**METROPOLITAN GOVERNMENT OF NASHVILLE AND DAVIDSON COUNTY**

**STAFF RECOMMENDATION**  
**2116 Ashwood Avenue**  
**December 17, 2014**

**Application:** New construction-addition  
**District:** Hillsboro-West End Neighborhood Conservation Zoning Overlay  
**Council District:** 18  
**Map and Parcel Number:** 10415019600  
**Applicant:** Jennifer Bagwell  
**Project Lead:** Paul Hoffman, paul.hoffman@nashville.gov

<p><b>Description of Project:</b> The application is for construction of an addition and screened porch to the rear and side of the house.</p> <p><b>Recommendation Summary:</b> Staff finds the project meets the design guidelines for the Hillsboro-West End Neighborhood Conservation Zoning Overlay, and recommends approval with the condition that Staff approve the final details, dimensions and materials of windows and doors prior to purchase and installation.</p>	<p><b>Attachments</b> <b>A:</b> Photographs <b>B:</b> Site Plan <b>C:</b> Elevations</p>
--	--

SITE INFORMATION FOR  
BUILDING PERMIT

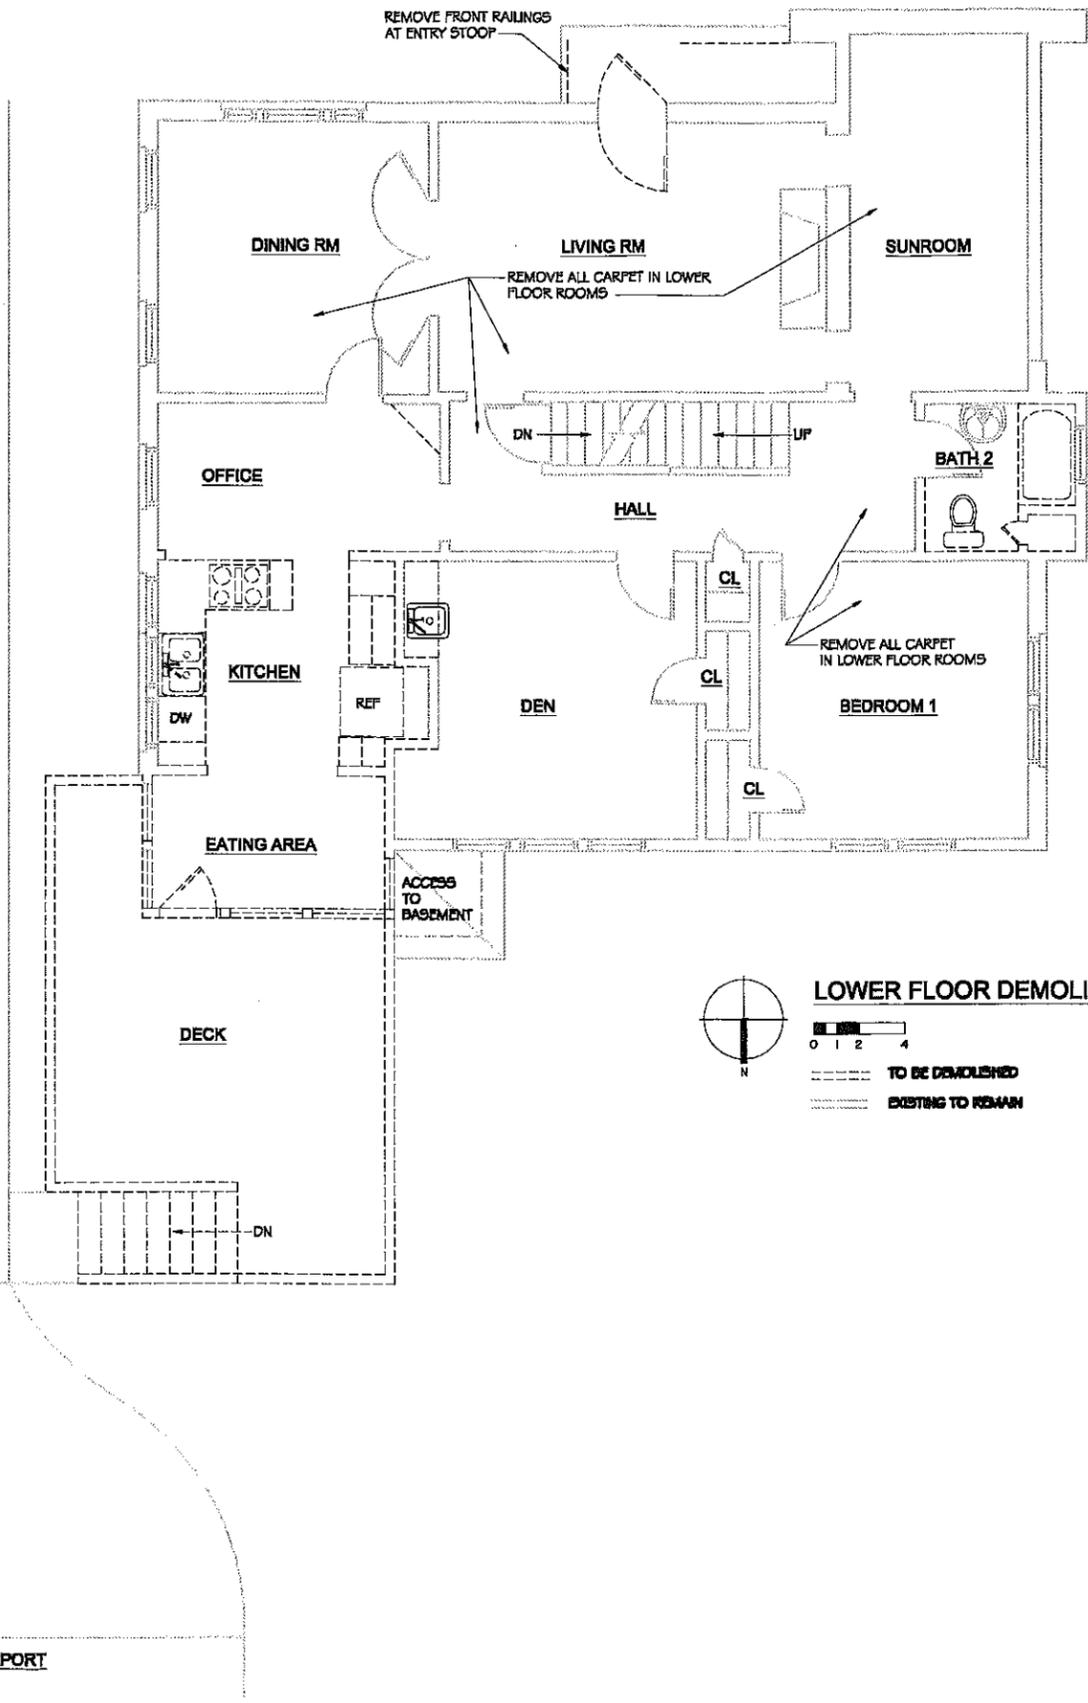
**Location & Removability:** The addition will be built to the rear of the existing rear porch and will extend four feet, two inches (4'2") beyond the right-side wall. The design guidelines allow for an addition to be wider when the lot is wider than sixty feet (60') and the house is shifted to the side of the lot, which is the case here. The original form of the house will remain intact. The addition will be subservient in massing to the house. The project meets section II.B.2.a and e.

Setback & Rhythm of Spacing: The addition will be fifteen feet (15') from the right side property line and twenty-six feet (26') from the left side property line. It will be thirty-eight feet (38') from the rear property line, meeting setback requirements of five feet (5') and twenty feet (20'). The project meets section II.B.1.c and II.B.2.a.

**LOWER FLOOR DEMOLITION PLAN**

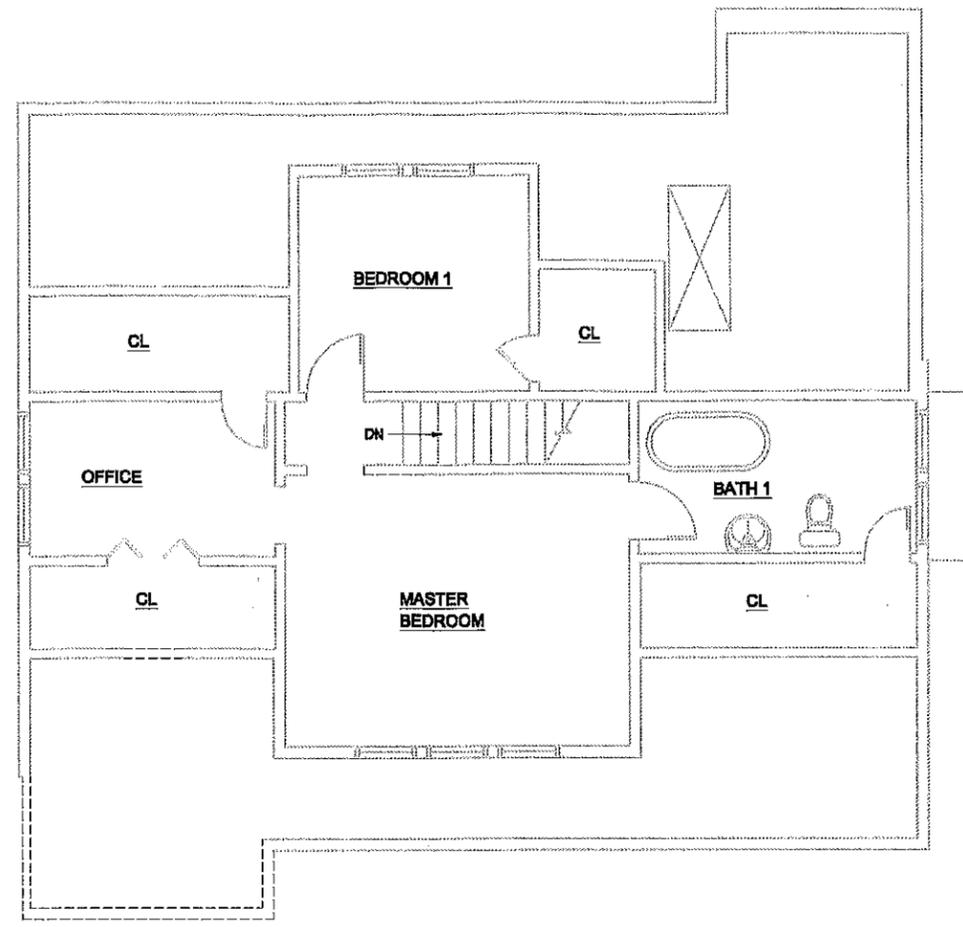
**Demolition:** The project includes demolition of the rear deck and an existing rear addition. Their removal will not be detrimental to the architectural or historical integrity of the building. The proposed partial demolition meets Section III.B.2 for appropriate demolition and does not meet section III.B.1 for inappropriate demolition.

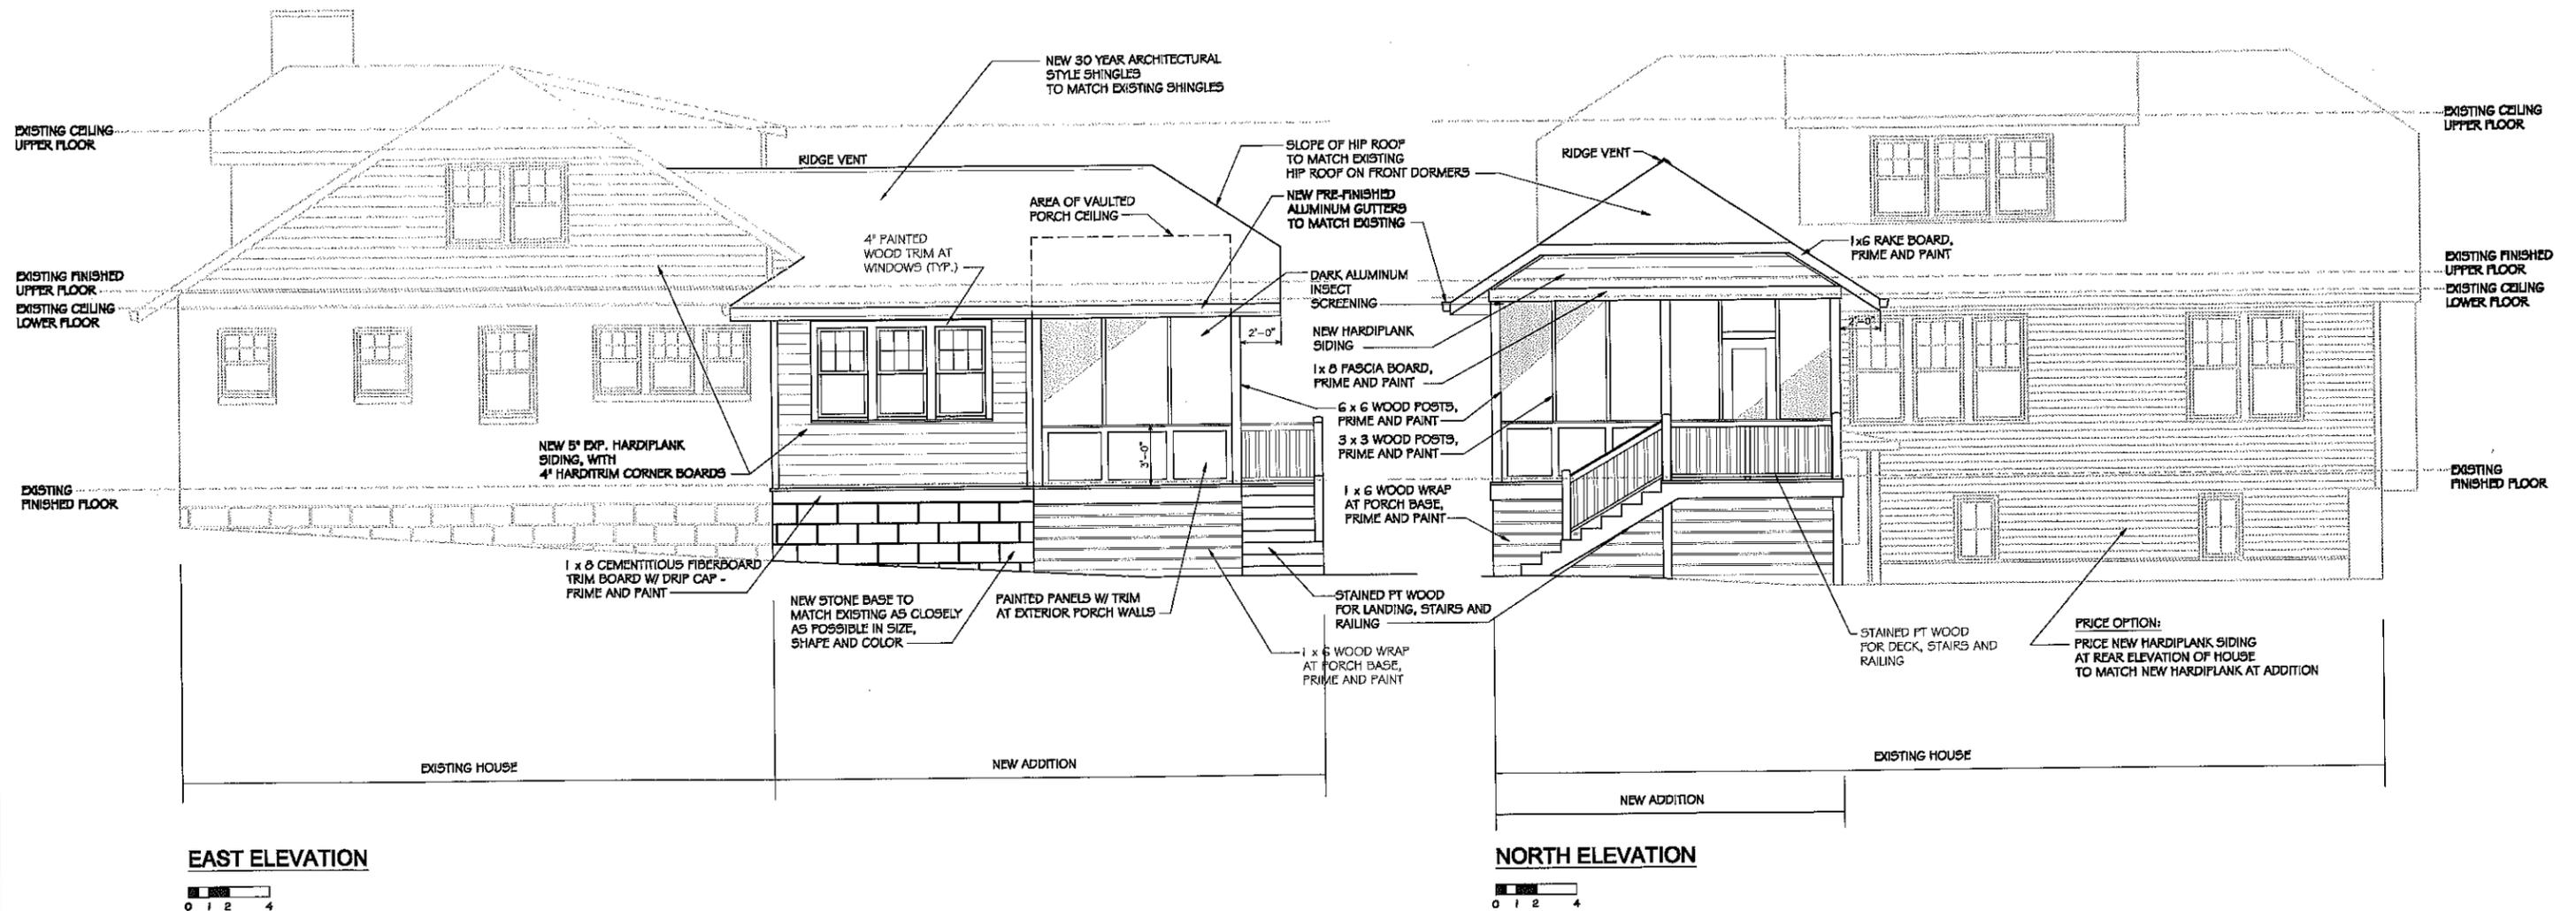
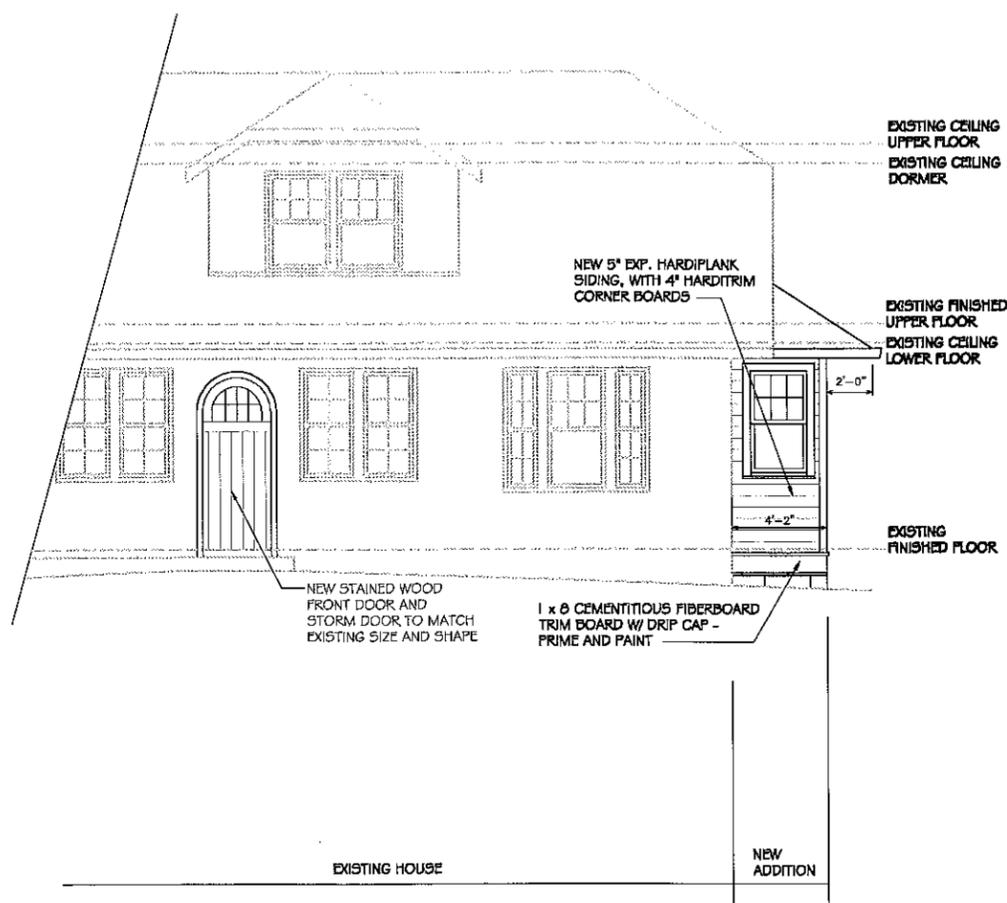
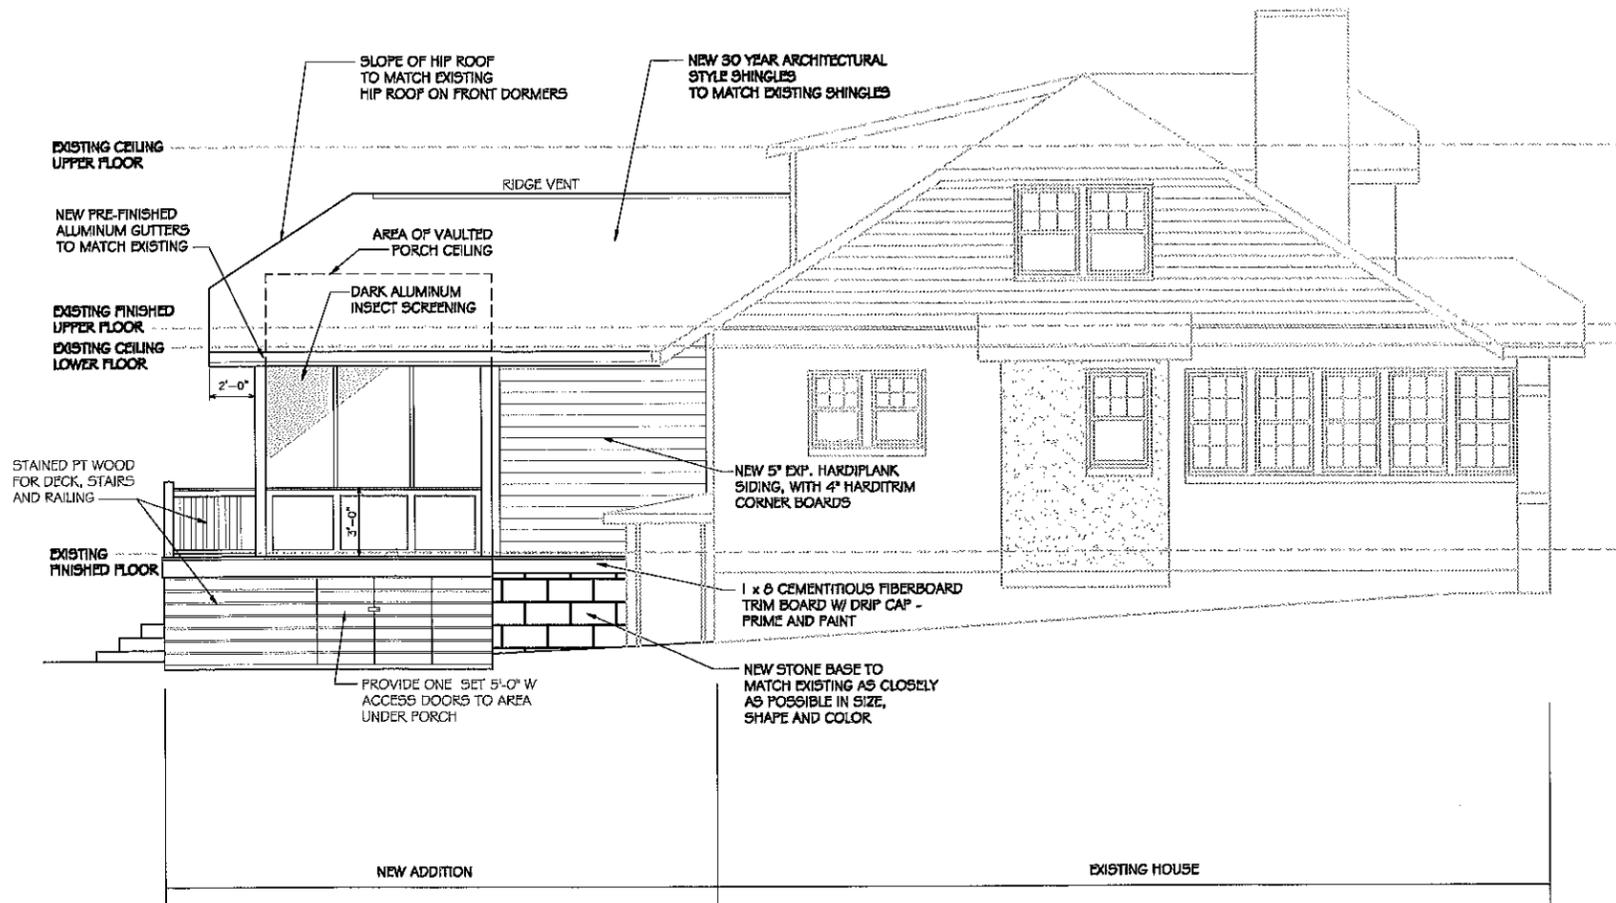
Materials: The addition will be clad in fiber cement siding, panels and trim. The siding will have five inches (5") of reveal. The foundation will be stone. Roofing shingles will match the existing roofing material in design and color. The screened porch will have wood posts and aluminum screening. The porch deck, steps and railing will be wood. Staff recommends administrative review of the wood windows and doors.

Roof form: The addition will have a hipped roof with 8/12 pitch matching the existing roof form and pitch of the house. The roof is compatible with the house and the context. The project meets section II.B.1.e.

Proportion and Rhythm of Openings: Several window openings inside the proposed porch area will be replaced. As these windows are in a rear porch enclosed at an unknown date, staff finds the proposed proportion and rhythm of openings meets section II.B.1.g.

Staff finds the proposed addition meets the design guidelines, and recommends approval of the project with the conditions that Staff approve the final details, dimensions and materials of windows and doors prior to purchase and installation.
